ADDENDUM NO. 2

CONTRACT NO. 19-514

Low Rise Building Renovations and HVAC Improvements
110 Dr. Martin Luther King Jr. Boulevard
White Plains, New York

Photos of Windows at “Bridge” Location where Material and Refuse Access is Provided.

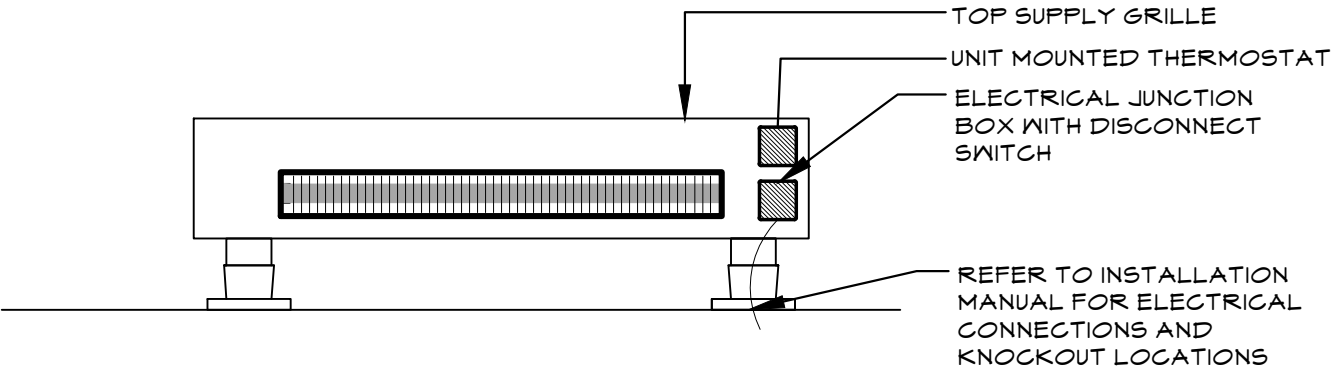
A. Construction Access Revised: The window removals allowed per drawing DM-006 issued with Addendum 1 are revised. The windows at the "Bridge" area where access to be provided for deliveries and removals are ribbon windows, not individual windows as previously assumed. The contractor may remove up to 6 windows in the one bay shown in the photos attached. As note previously, any opening created for material access shall be provided with a weather tight temporary enclosure and sealed when not in use. Any removed windows must be stored and re-installed before completion of the project.

1
DSK-M-01

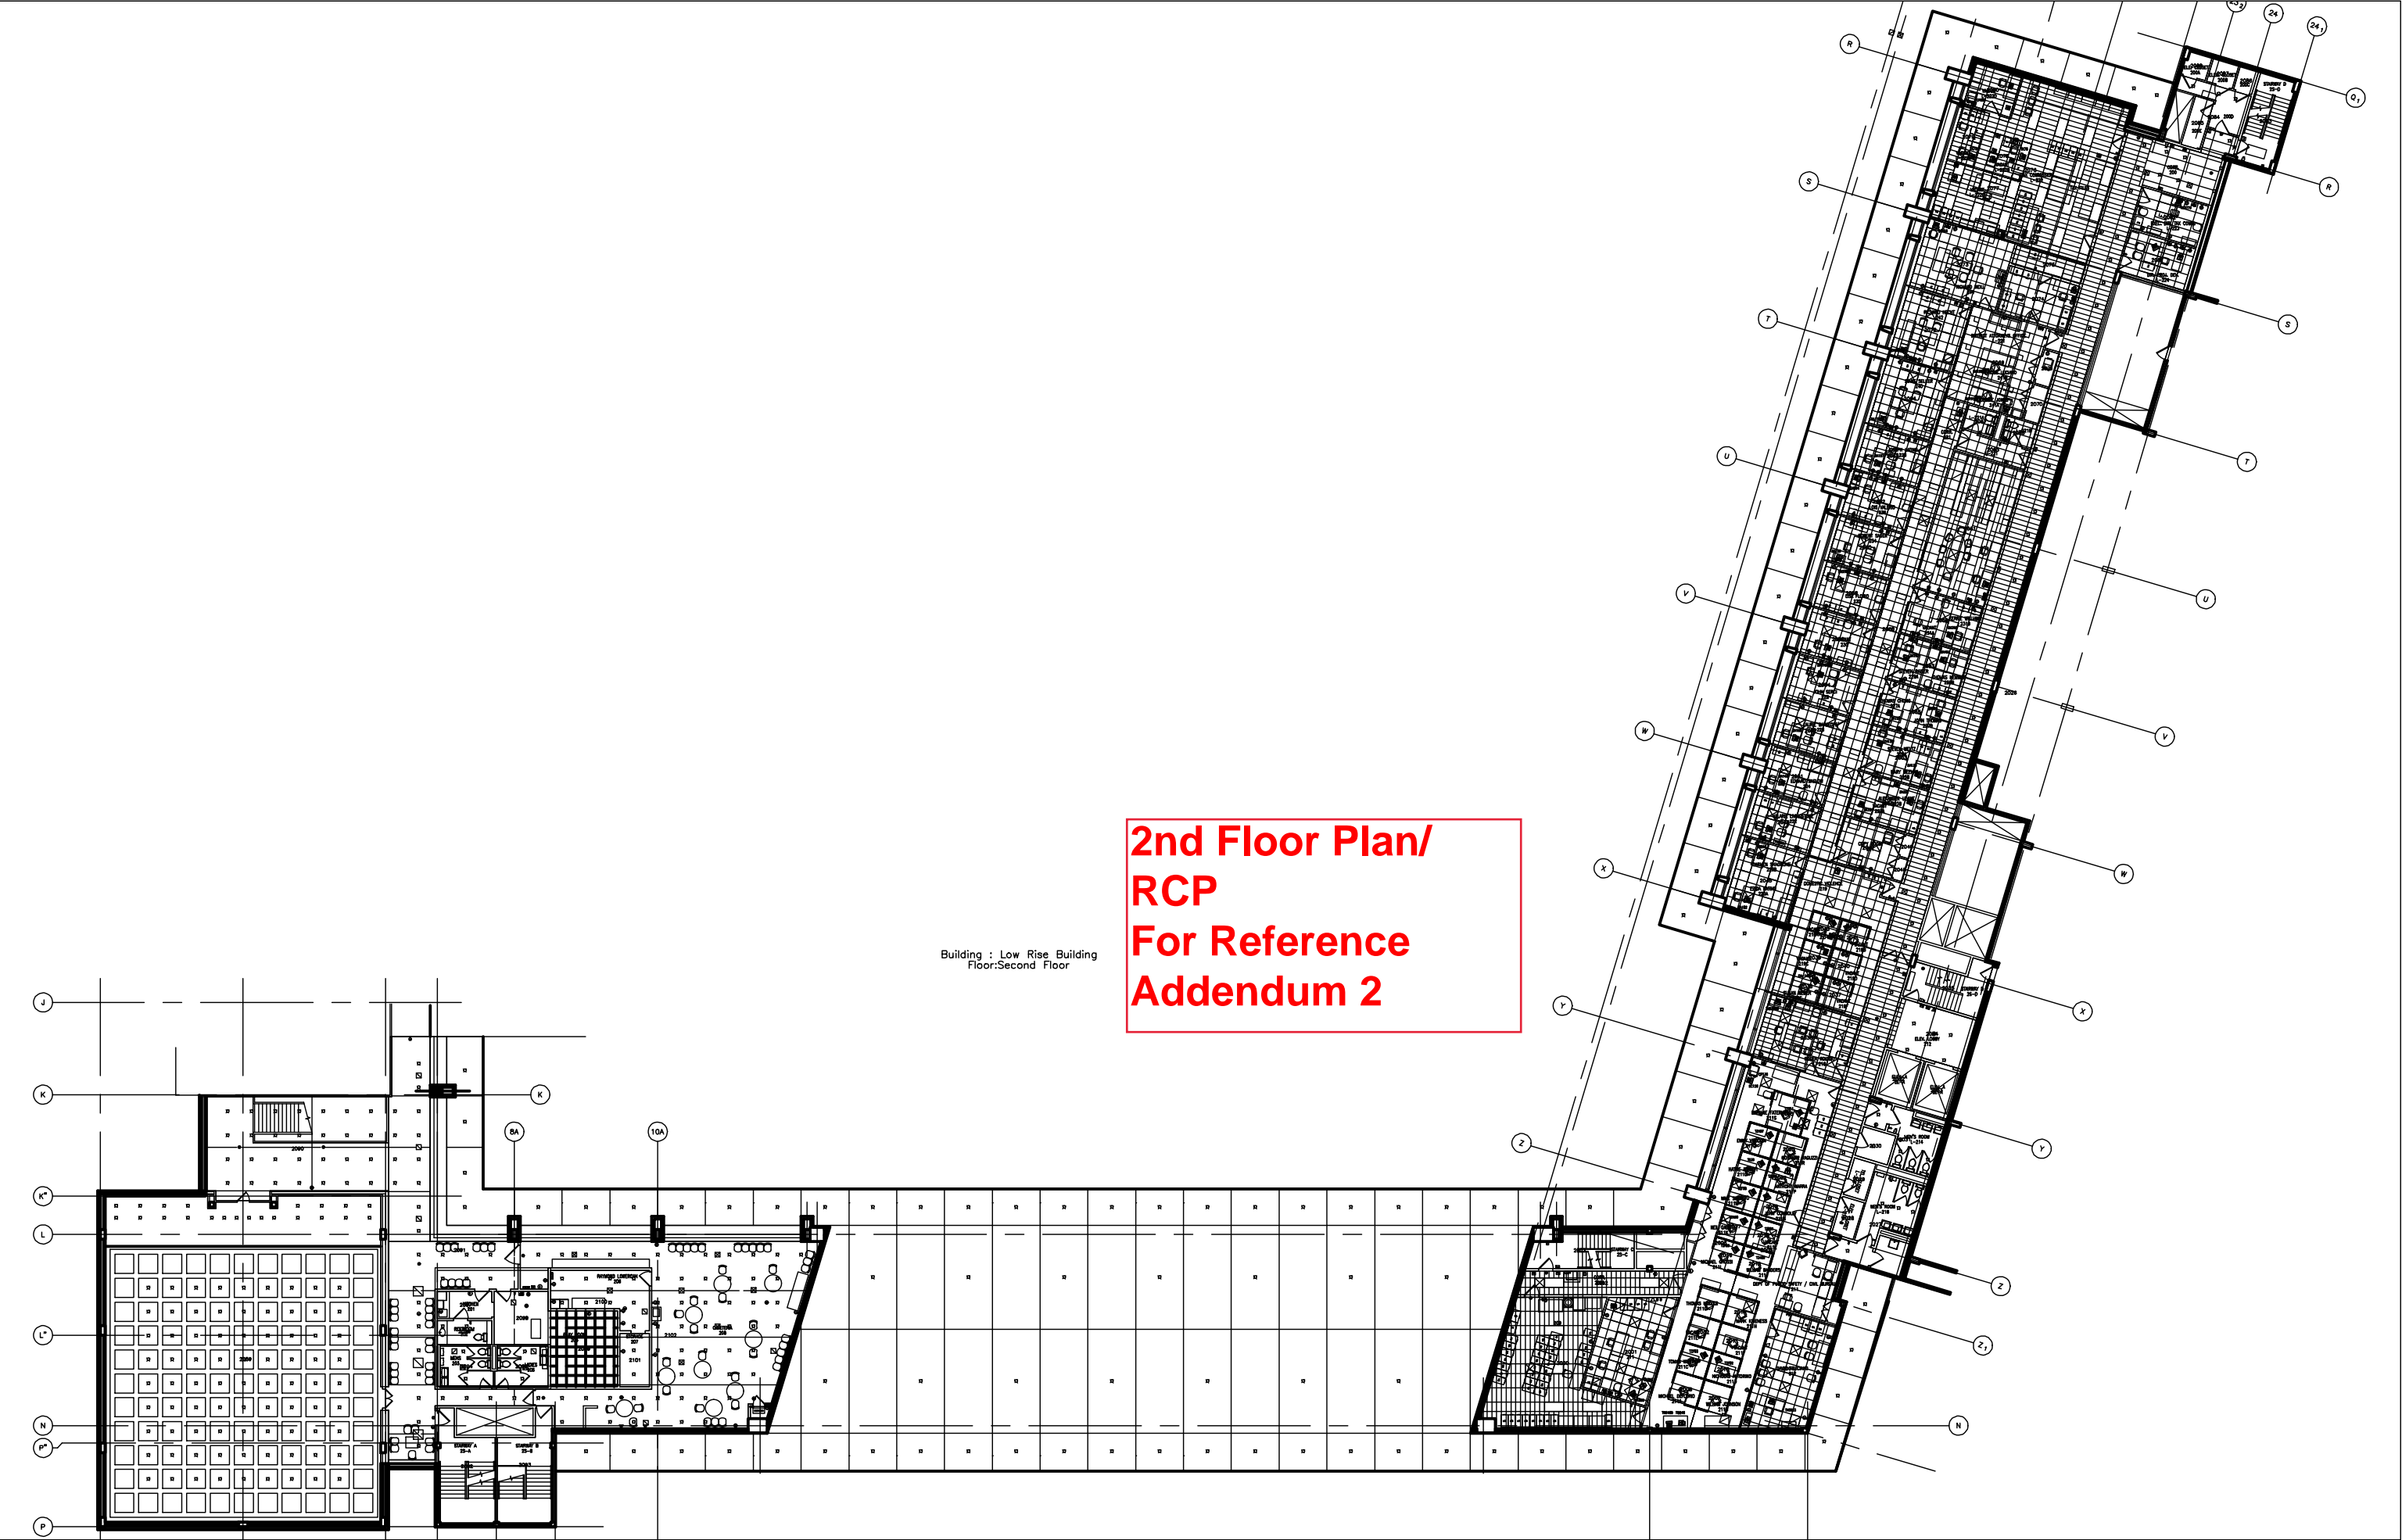
9	Please provide details for #EBB electric baseboard schedule On Drawing M-011	Please see Mechanical sketch DSK-M-01, attached.
10	Hydronic Specialties In regards to the “Hydronic Specialties, Chemical Treatment & HVAC Water Treatment” <ul style="list-style-type: none"> - 3.6 F. is calling for a “chemical feeder where indicated”. - None are shown on the drawing. - Will this be required? 	Bypass chemical feeder not required per design drawings. Chemical treatment equipment is part of base building system. Coordinate with building as required.
11	Chemical Treatment. 3.8 A 4 “Modify this value if closed system contains glycol”. <ul style="list-style-type: none"> - Will this require glycol to be added to the system? - Is this a closed system? - If it is can we reuse the existing and add back to the system once all equipment piping is complete? 	Analysis to be performed by approved vendor as per specification section 232113 3.8. Yes it is a closed system. Per section 232113 3.8B, system is to be filled with fresh water after circulating emulsifying agents and detergents.

1 REFLECTED CEILING PLAN - 3RD FLOOR NORTH WING
1/8" = 1'-0"

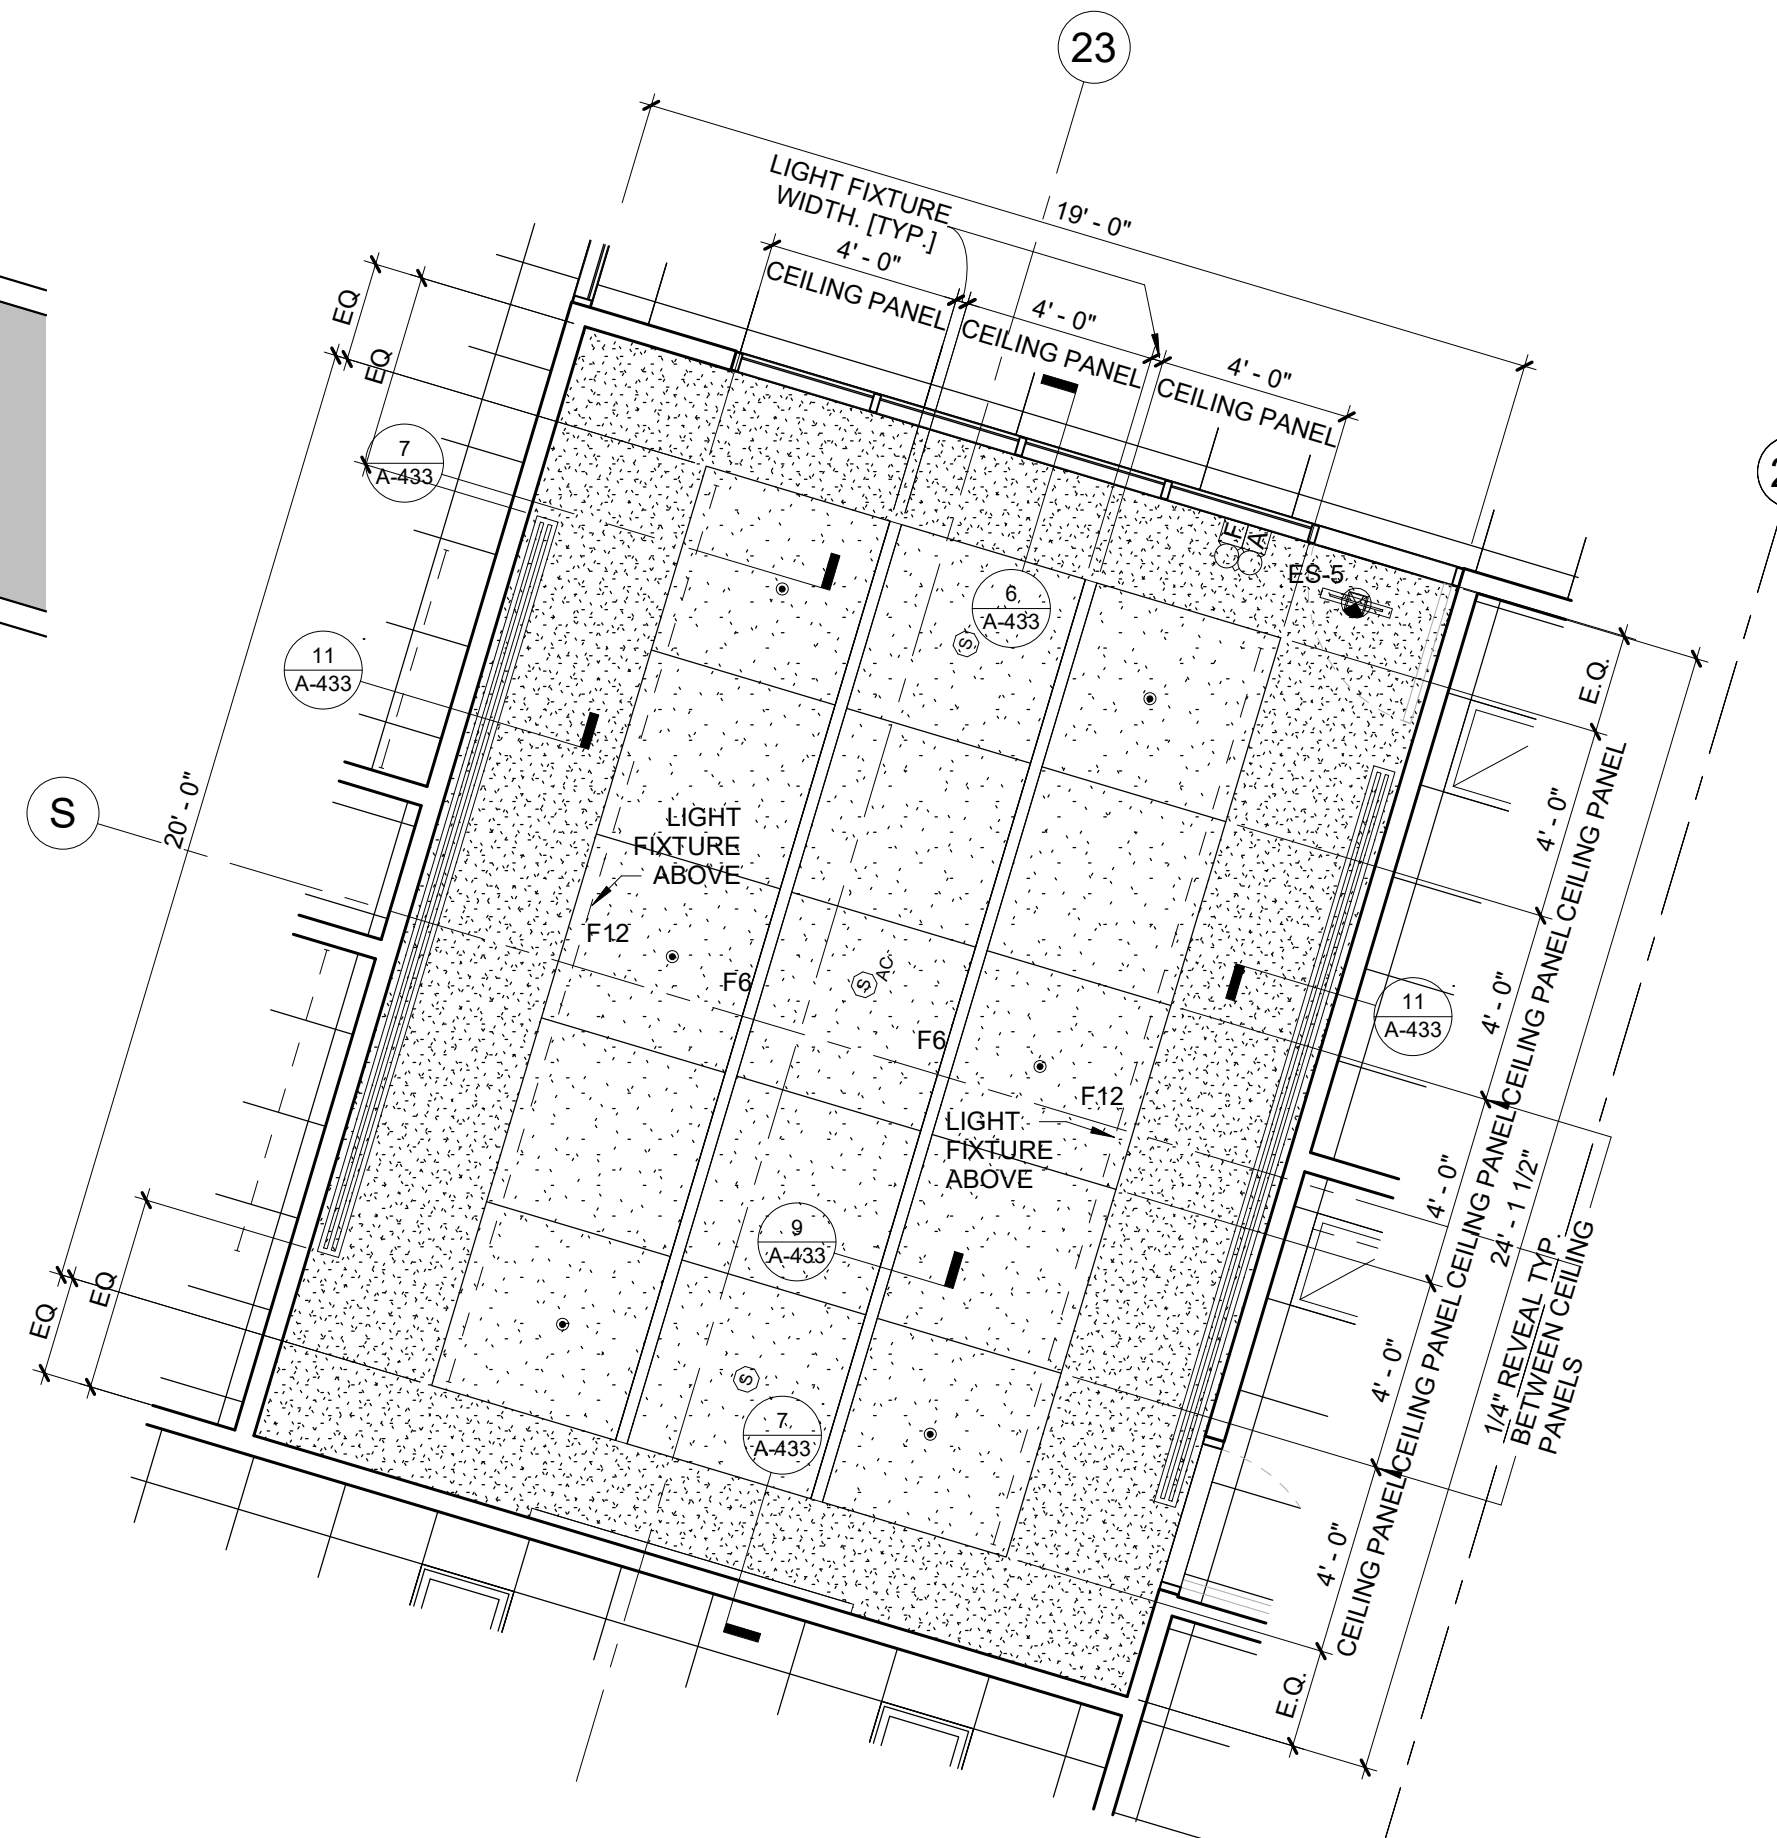
D. Corridor Lighting Circuiting Drawing: We have attached drawings E-040 and E-203 to show lighting circuiting at the North section of the corridor. The architectural Reflected Ceiling Plan A-114 showing this lighting and ceiling conditions was issued under Addendum #1.
